SOUTHWEST BIKEPATH CULVERT REPLACEMENT AT WAITE CIRCLE - 2019

CITY OF MADISON, WI

CITY PROJECT NO. 8466

ADDENDUM 1
8/29/19
CHANGED ENTIRE
DRAWING

DRAWING NUMBER
C-7
 SHEET NUMBER
13 OF 25

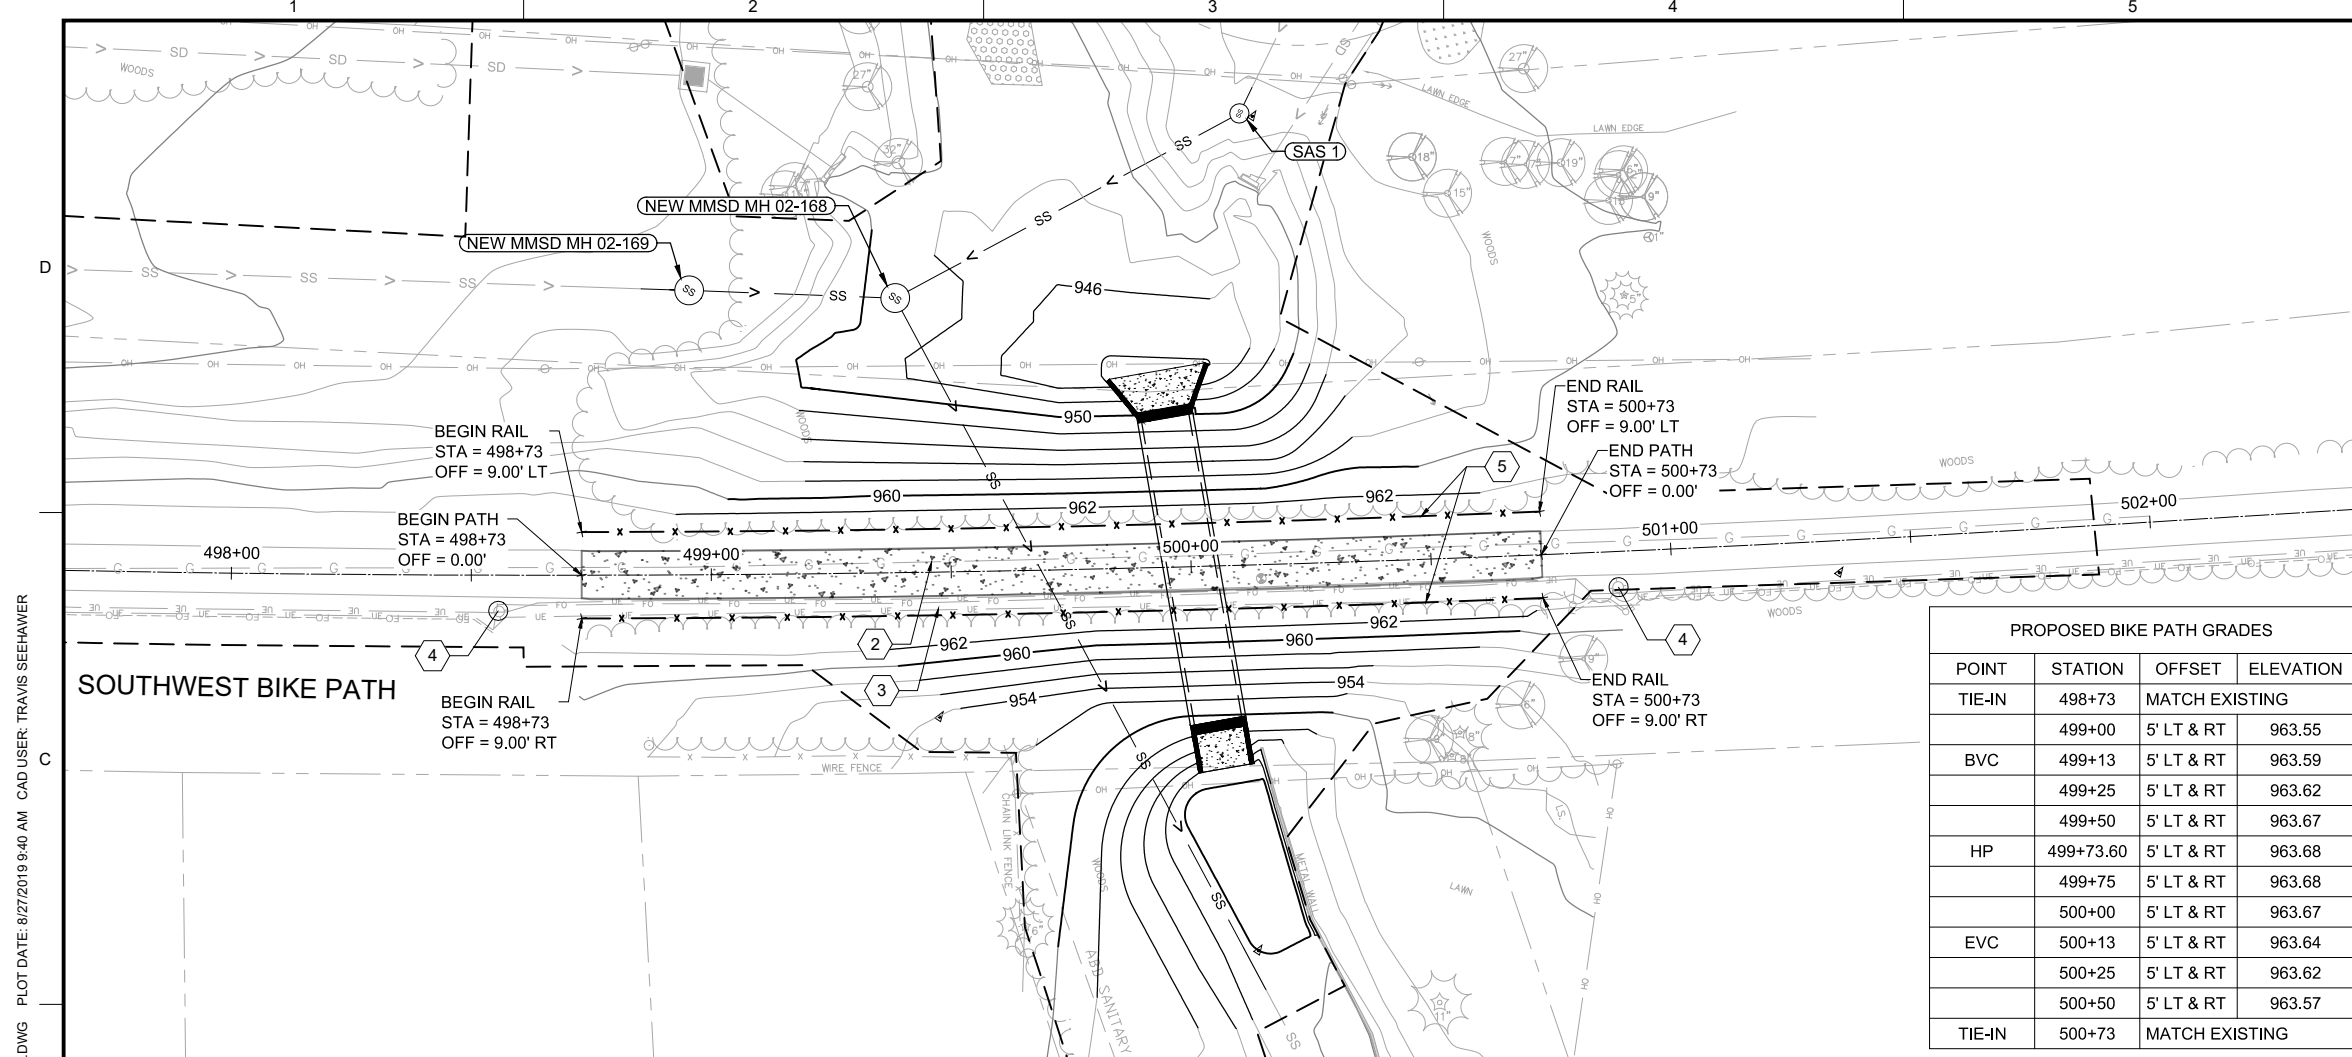
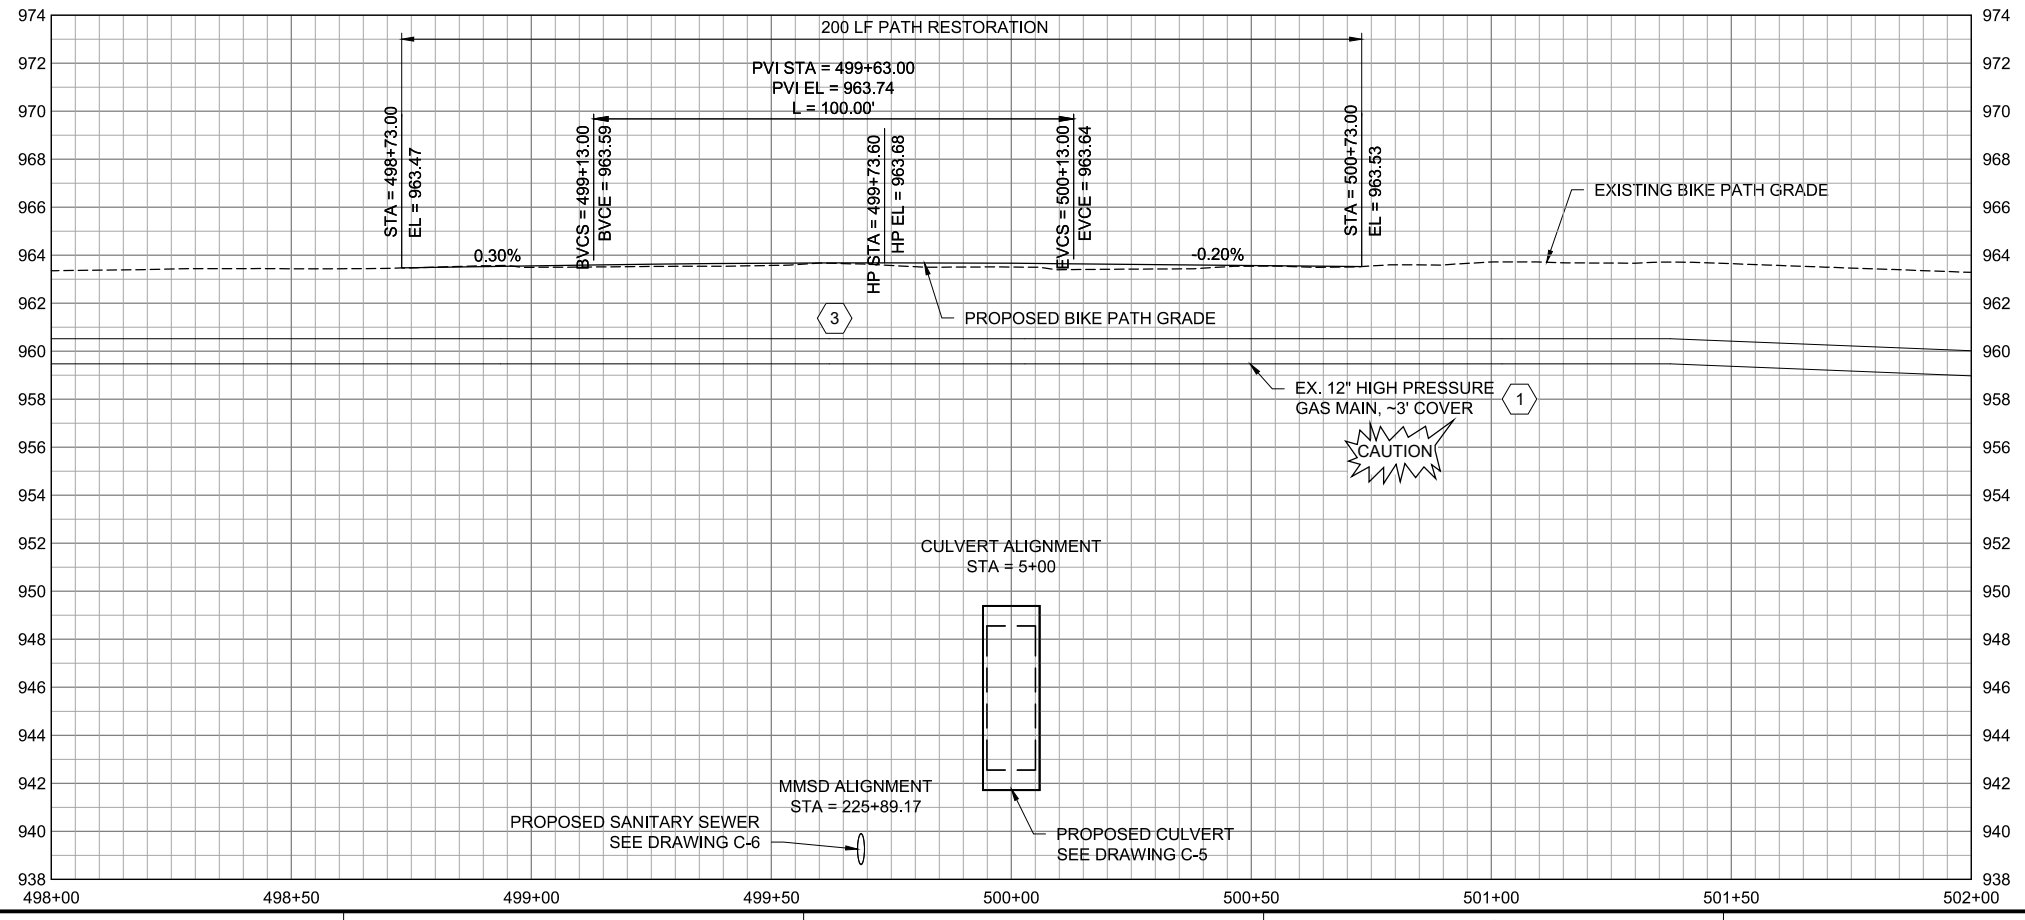
**ADDENDUM 1
CHANGED
ENTIRE
DRAWING**

DRAWING NUMBER: **C-8**
 SHEET NUMBER: 14 OF 25

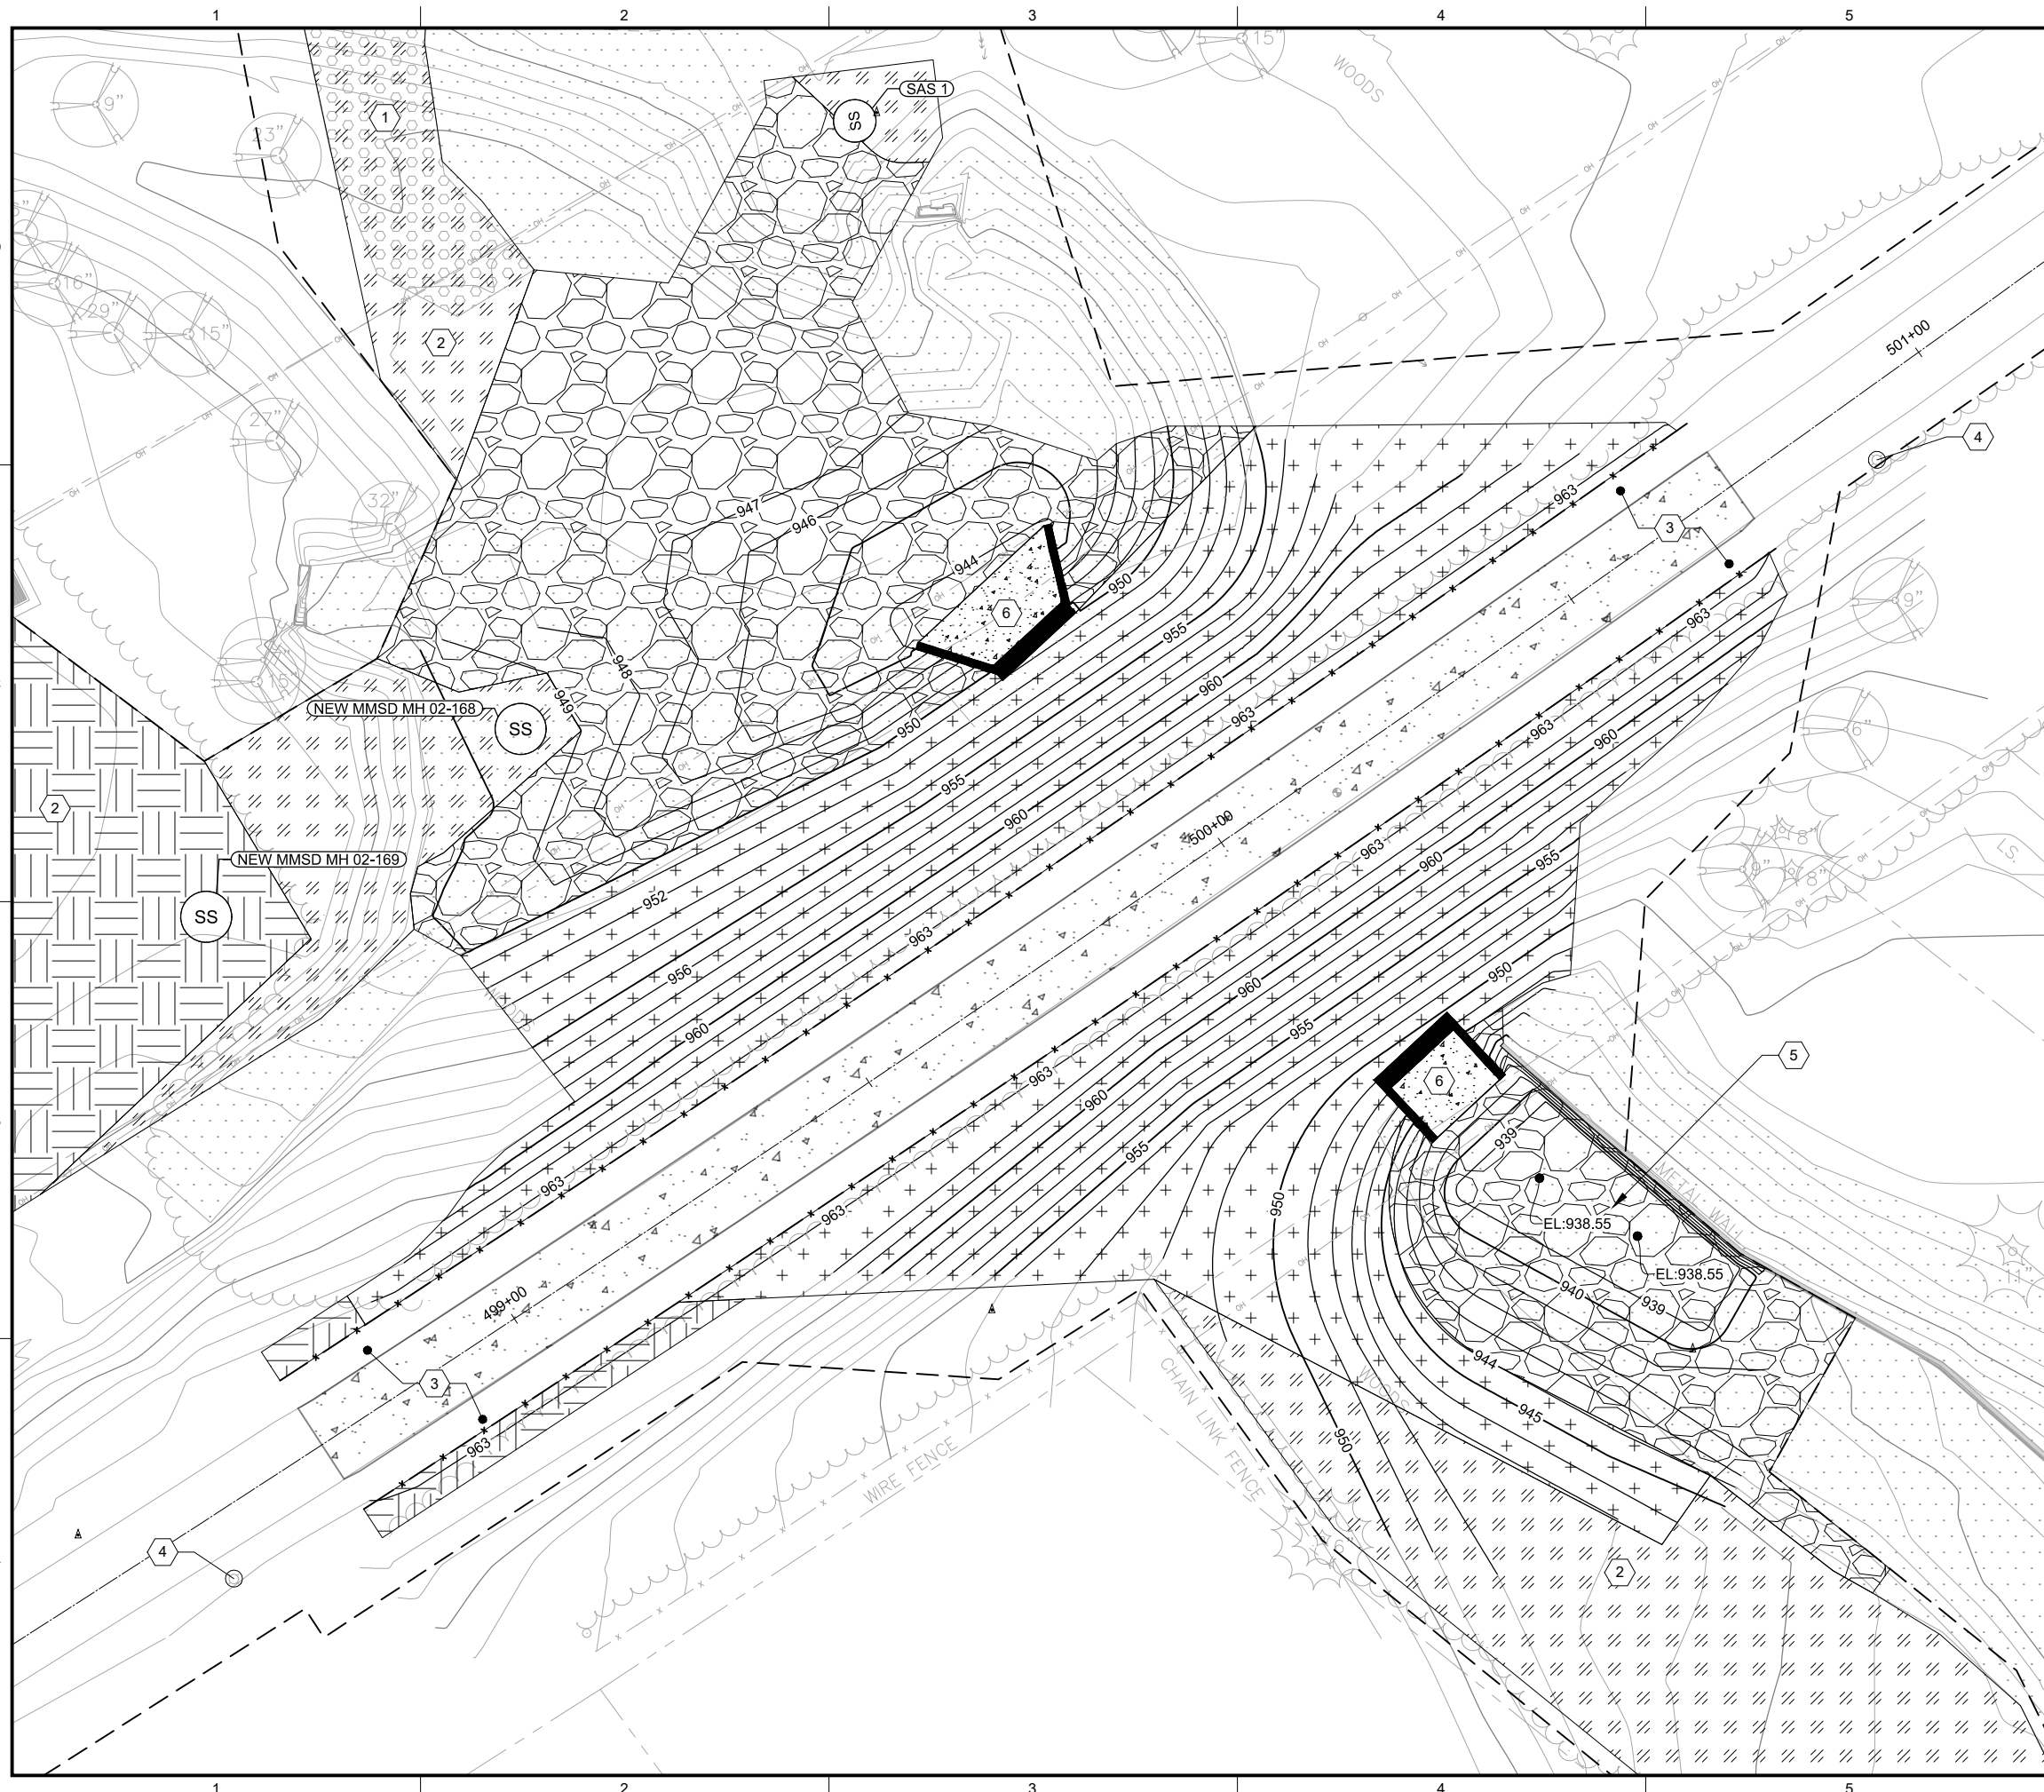
ADDENDUM 1 CHANGED ENTIRE DRAWING
